ADDENDUM NO. 3 TO PROJECT NO. M3042

**ELECTRICAL WORK
RESTORE TRANSFORMER AND ELECTRICAL SERVICE CABLES
BUILDINGS 5, 7 & 9
ELMIRA PSYCHIATRIC CENTER
100 WASHINGTON STREET
ELMIRA, NY 14901**

January 5, 2015

DWG NO:
SKE-1

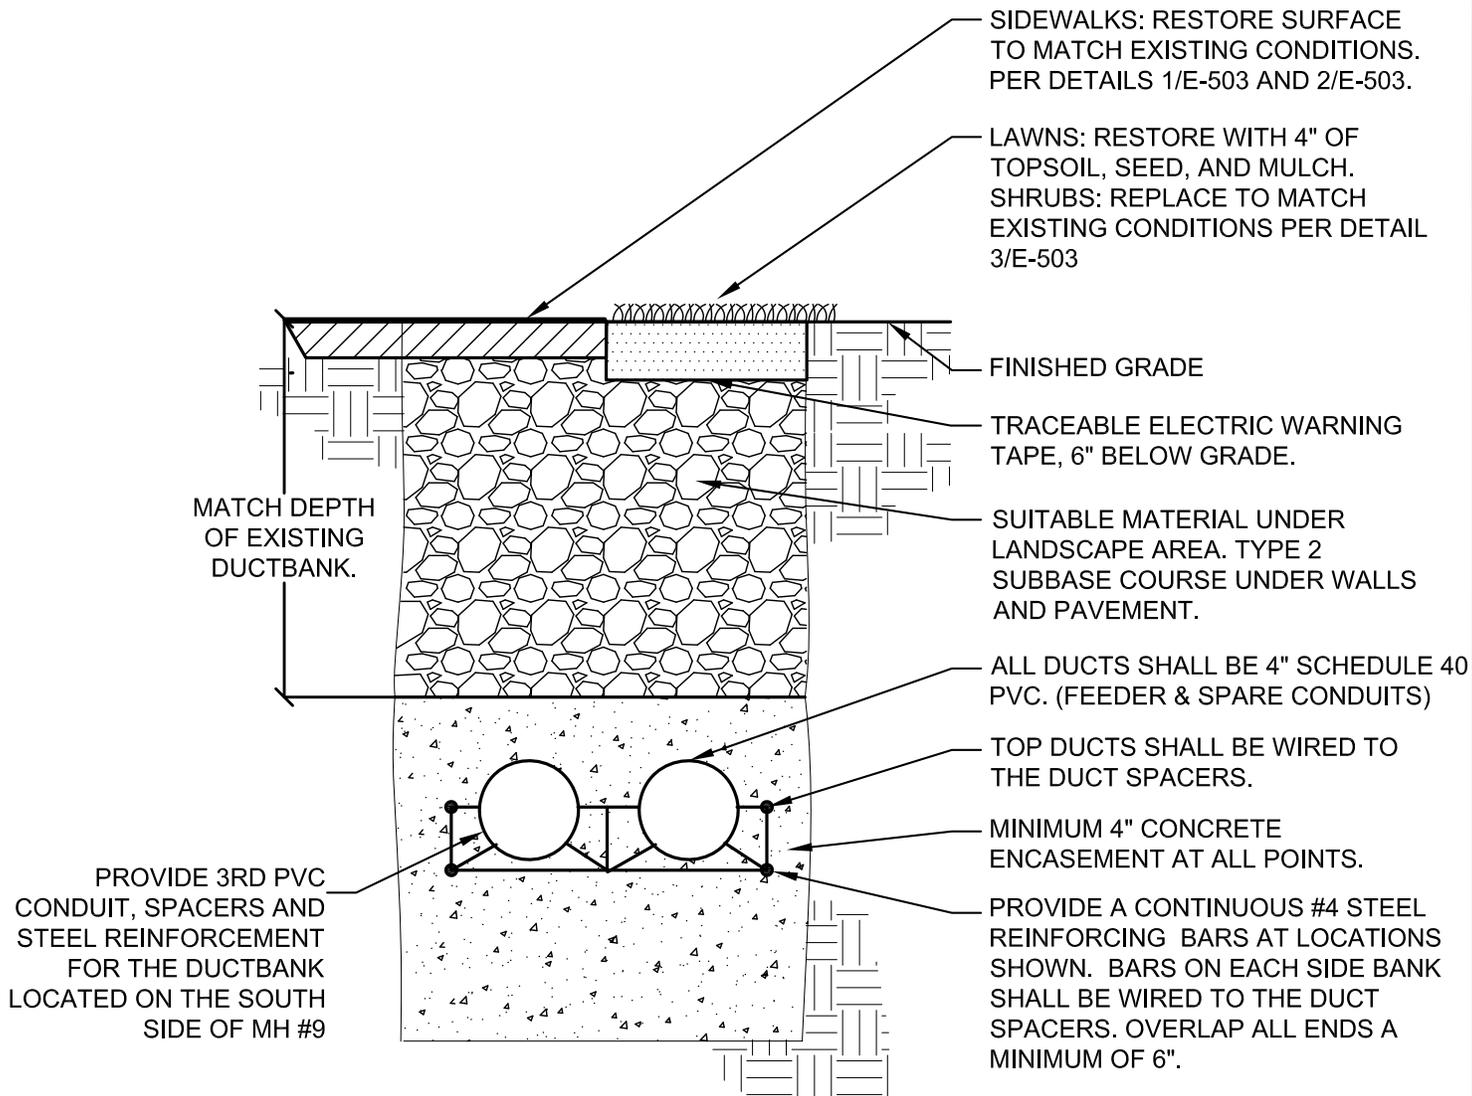
"Provide (1) 208Y/120V, 3-phase, 125KW potable diesel generator with 400 amp MCB. Generator shall be moved to each building to provide power while cable replacement occurs."
6. Addendum Sketch:
Sketch Nos. SKE-1 and SKE-2 accompanying this Addendum to form a part of the Contract Documents.
